Blythe Energy Center Transmission Line Project
Request for Staff Approved Modification
(99-AFC-08T)
Response to Data Request - Revised 2/8/11

TECHNICAL AREA: Transmission System Engineering
AUTHOR: Ajoy Guha

DATA RESPONSES

JOB NUMBER	REV
115210	△
DRAWING NUMBER	
P1-1

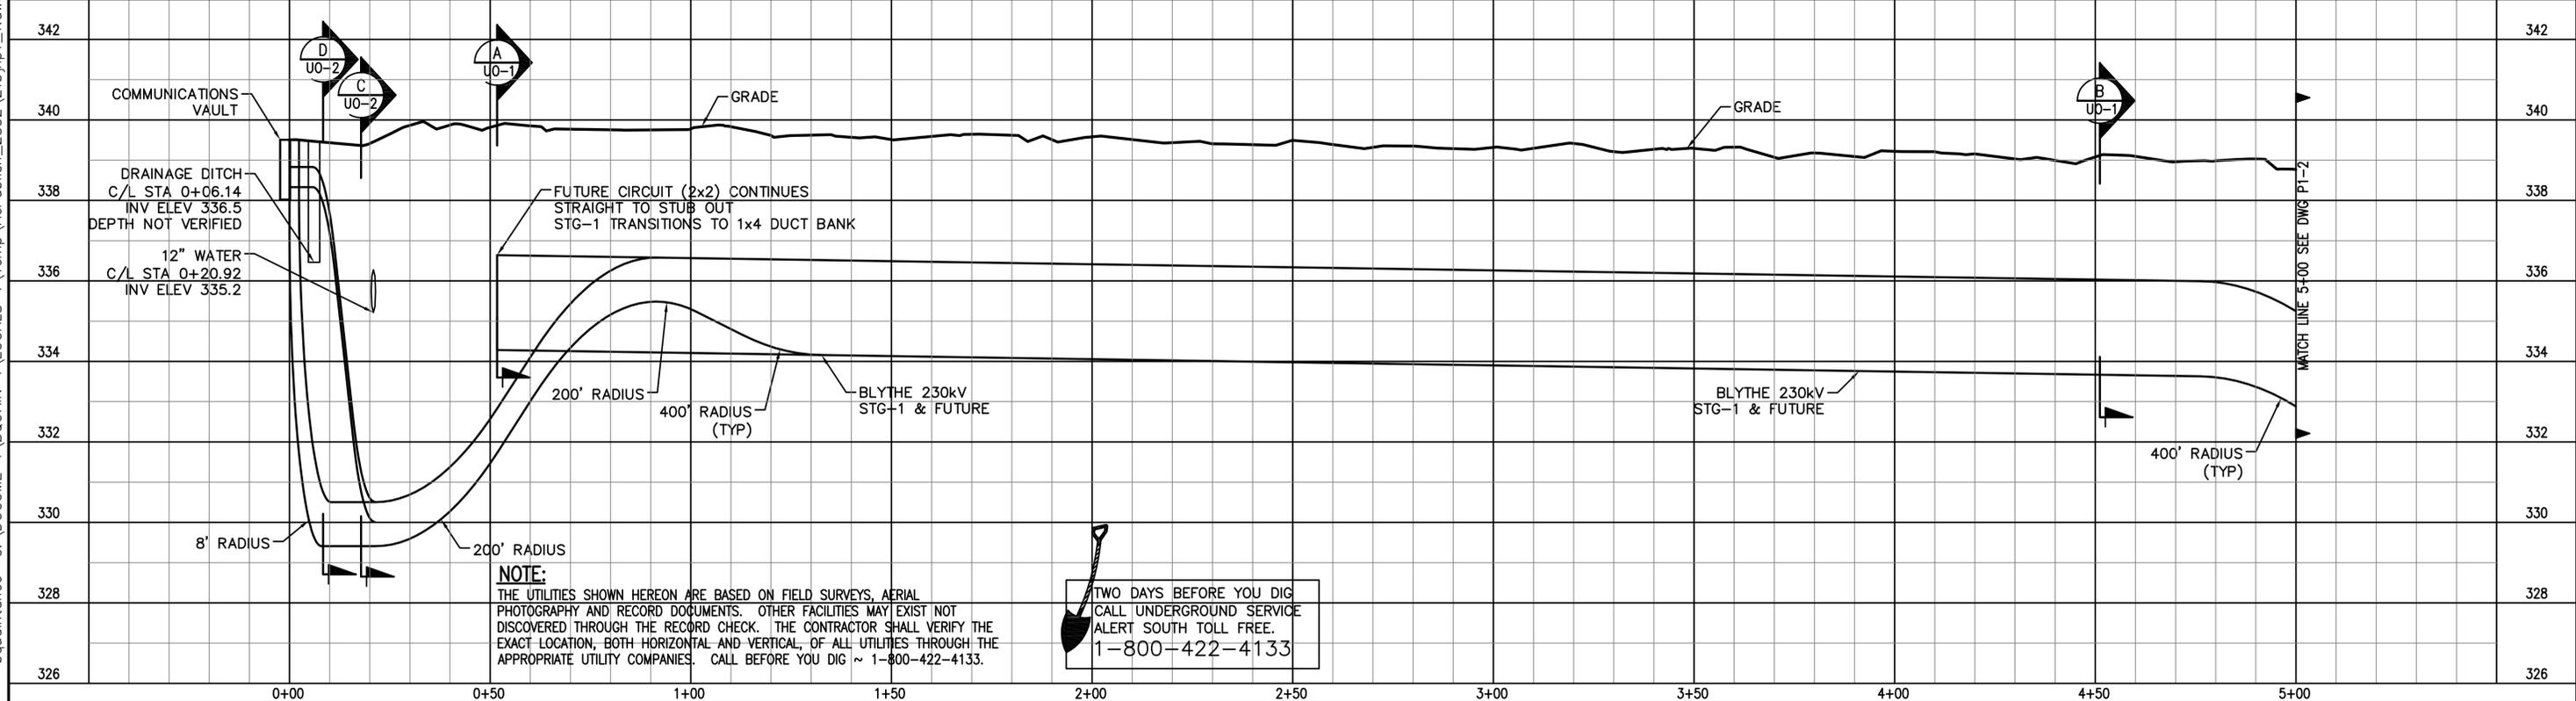
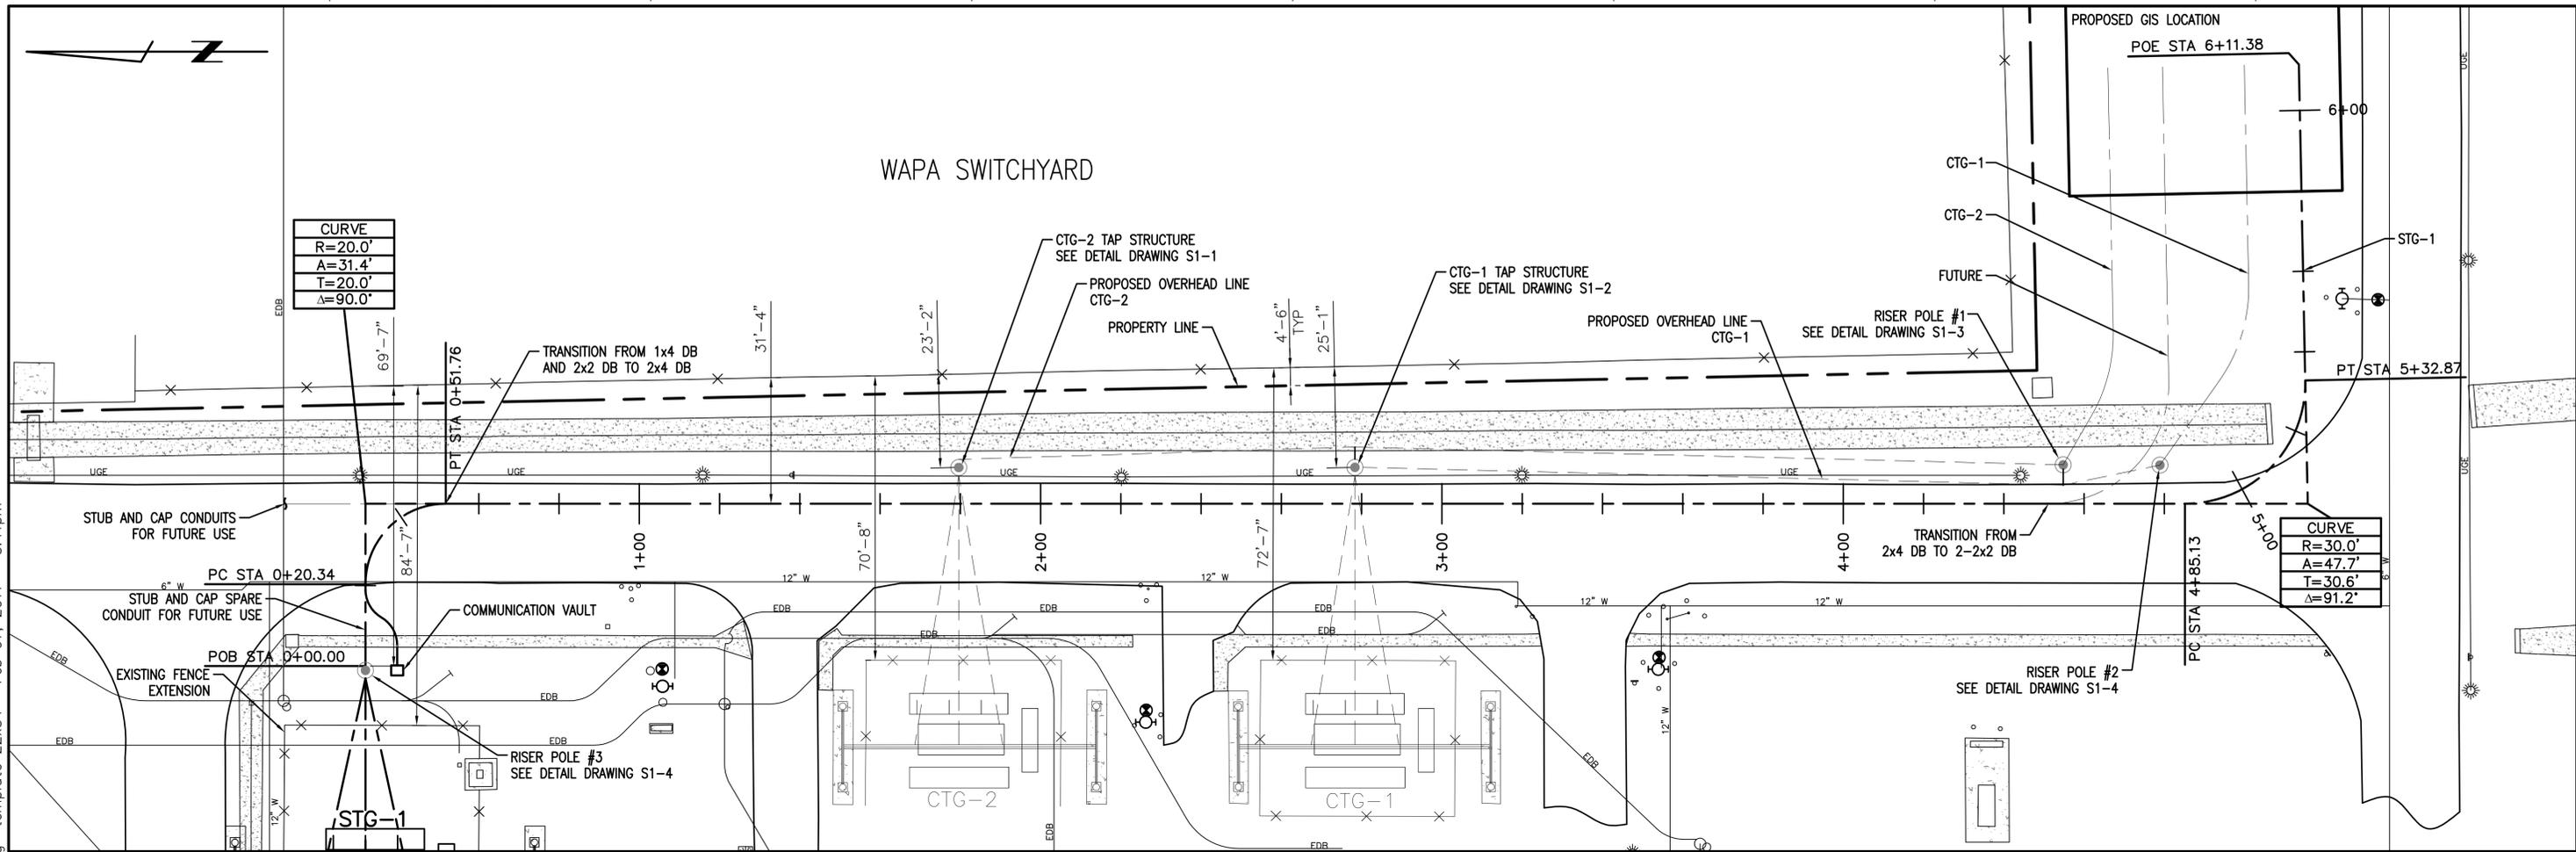
DATA REQUEST 1: Provide respective lengths of the overhead and underground portions of the tie lines and a physical layout scaled drawing (legible) showing distinctly the routes of the proposed 230 kV lines from the BEP 230 kV switchyard to the new 230 kV GIS substation and relative spacing between the lines including Right of Way (ROW) widths, if any.

DATA RESPONSE 1: Figure 1 shows an isometric overall view of the overhead and underground portions of the line. Figure 4, sheets GO-1 and P1-1 and Figure 5, sheets P1-1 through P 1-6, are scaled drawings showing the routes of the proposed 230kV lines from each of the BEP turbines, including a future position, to the new 230kV GIS. Note that the interconnection with the substation will entirely bypass the existing Western (WAPA) substation. The interconnection between the turbines and the GIS will all be located entirely within the BEP property. No additional ROW will be needed.

Dimensions indicating distance between proposed T-lines and Switchyard fence and Switchyard property lines have been added to Figure 5, P1-1 through P1-6. Dimensions from the GSUs to the Switchyard fence have also been added to these drawings.

JOB NUMBER	REV
115210	△
DRAWING NUMBER	
P1-6

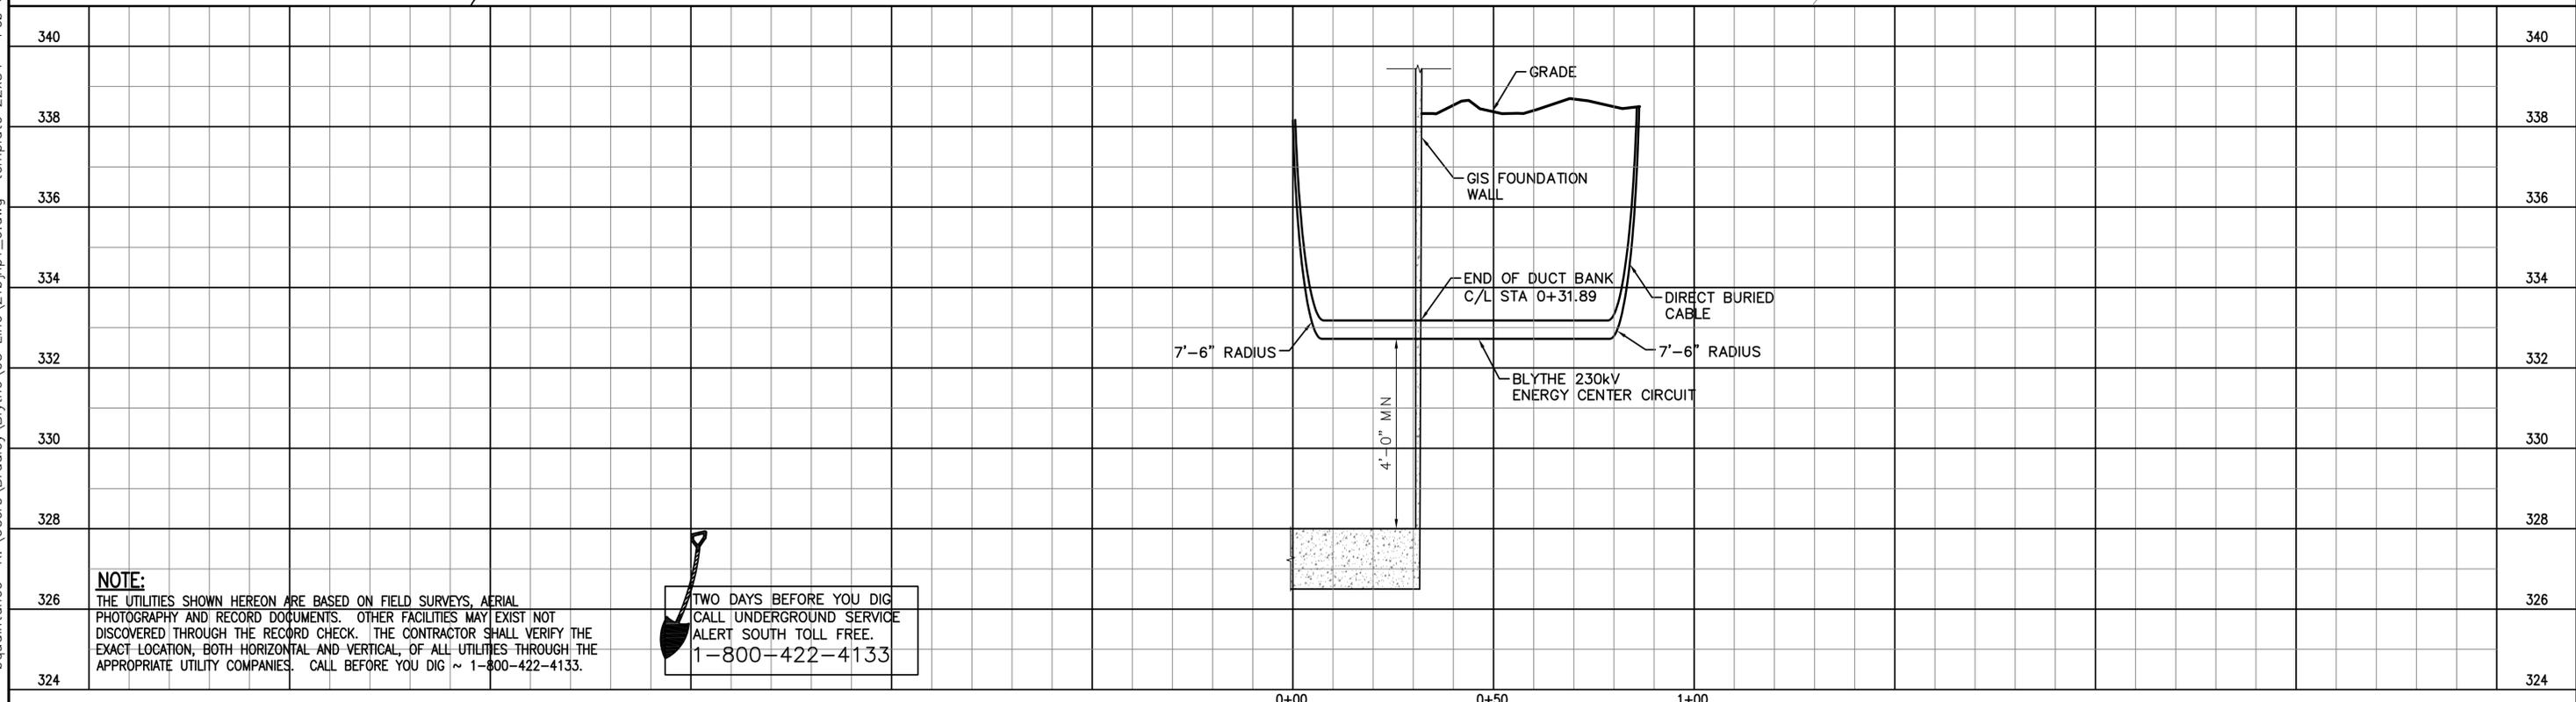
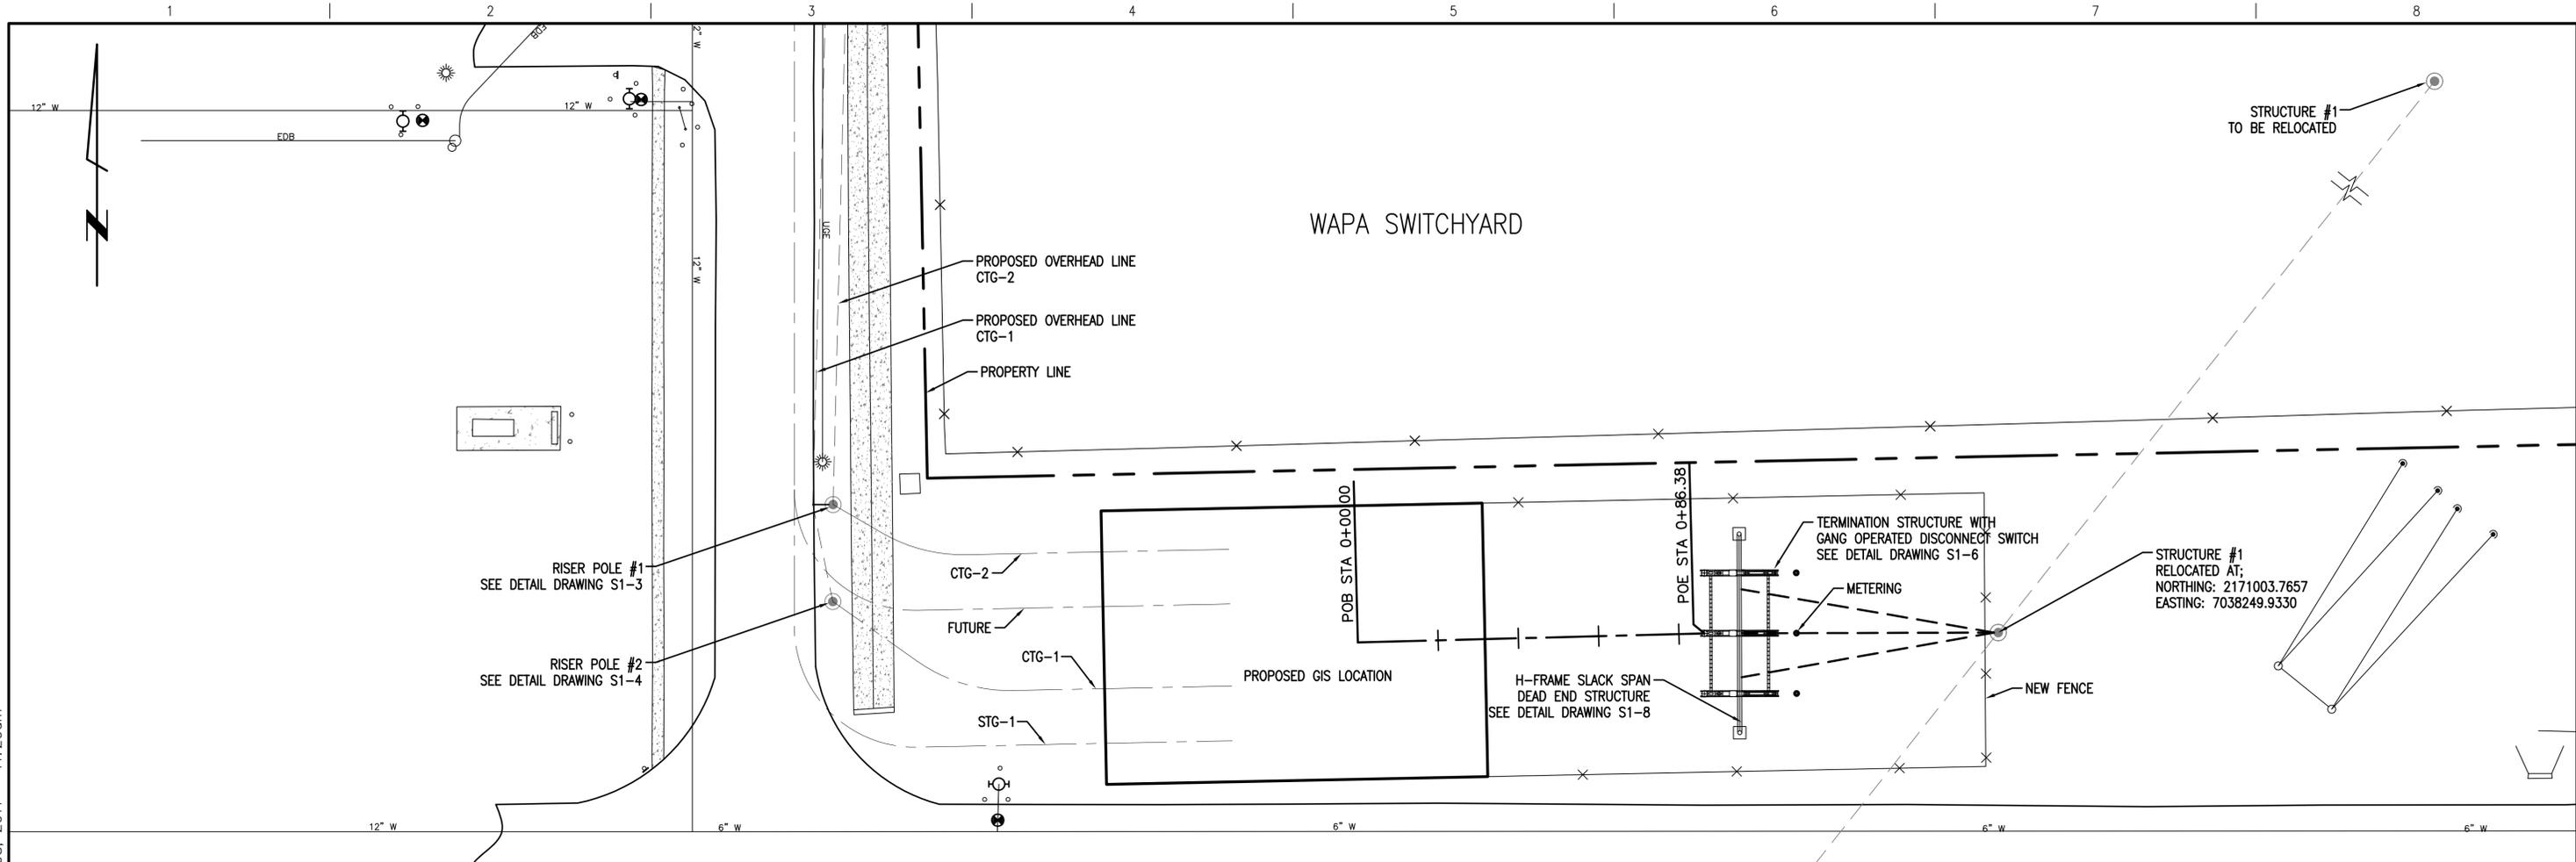
DATA REQUEST 6: Provide a scaled layout diagram showing how the existing BEP 230 kV transmission line to SCE Julian Hinds substation would be re-routed and connected to the new 230 kV GIS substation. Also provide a Pole design diagram with the overhead line conductor sizes and ampere rating.

DATA RESPONSE 6: Please see Figure 2, showing the scaled arrangement of the GIS, Figure 4, sheet P1-1, and Figure 5, Sheet P1-6.)Overhead conductor being used for the generator to GIS tap is 1033.5 kcmil ACSR 'Curlew' with an ampacity rating of 1047 amps. The Blythe to Julian Hinds line conductor is triple bundled 1033.5kcmil ACSR 'Curlew' with an ampacity rating of 2008 amps.

Figure 5, P1-6 has been updated to identify the reconfiguration of the existing Julian Hinds line showing the relocation of the existing T-line deadend structure and the tap to the new GIS deadend structure.

JOB NUMBER	REV
115210	B
DRAWING NUMBER	
U0-1

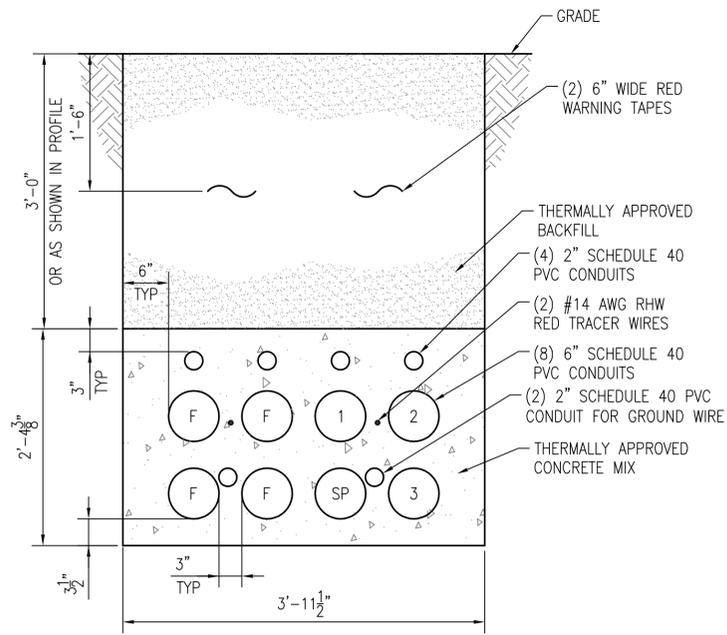
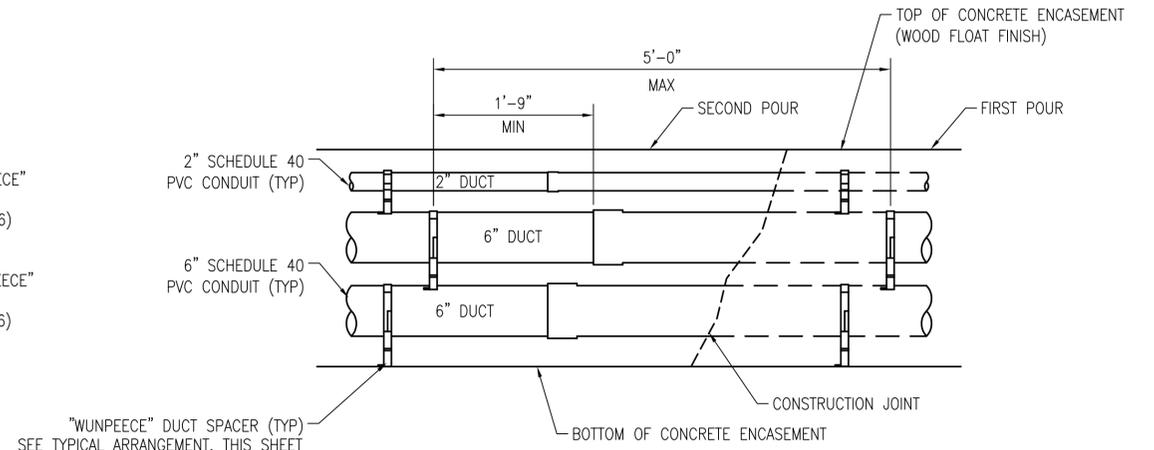
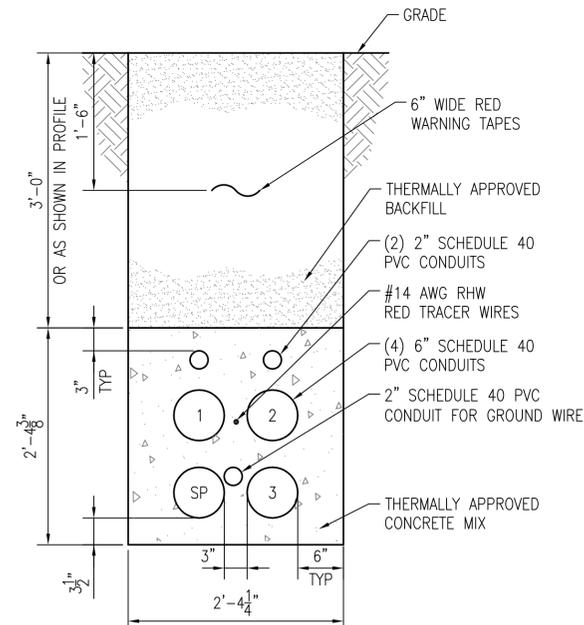
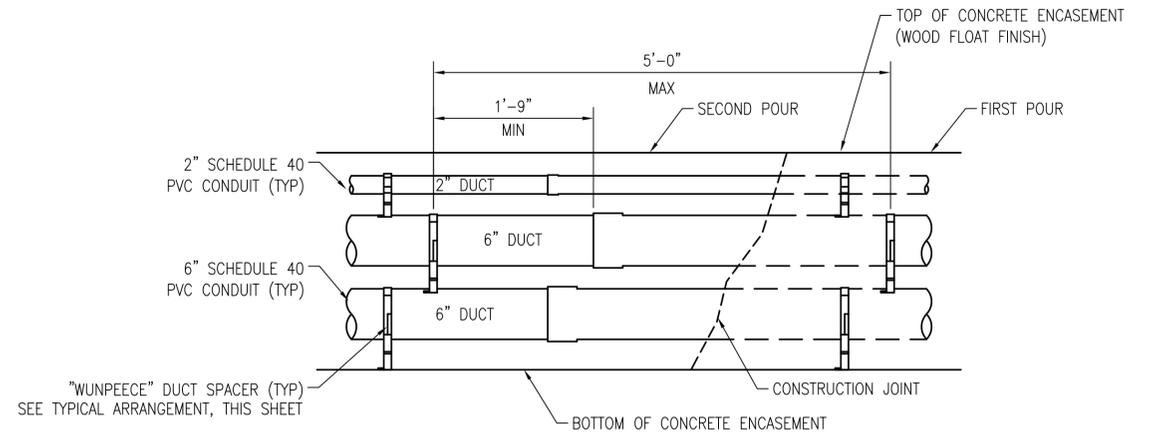
DATA REQUEST 4: Submit a design diagram of Duct Bank construction (or any other type) for the proposed 230 kV underground cable lines (including grounding and communication cables, if applicable). Provide the type, size and ampere rating of the 230 kV underground cables for all transmission outlets including BEP 230 kV line to Julian Hinds.

DATA RESPONSE 4: Please see Figure 5, sheets U0-1 through U0-3, for requested design diagrams of the duct bank construction for the proposed 230kV underground cable lines. The type, size, and ampere ratings are as follows:

For the interconnections from each turbine to the GIS, 1750kcmil copper conductor, carrying 457 amps, will be used. For the interconnection from the GIS to the Blythe-Julian Hinds 230kV transmission line, 5000kcmil copper conductor carrying 2058 amps will be used.
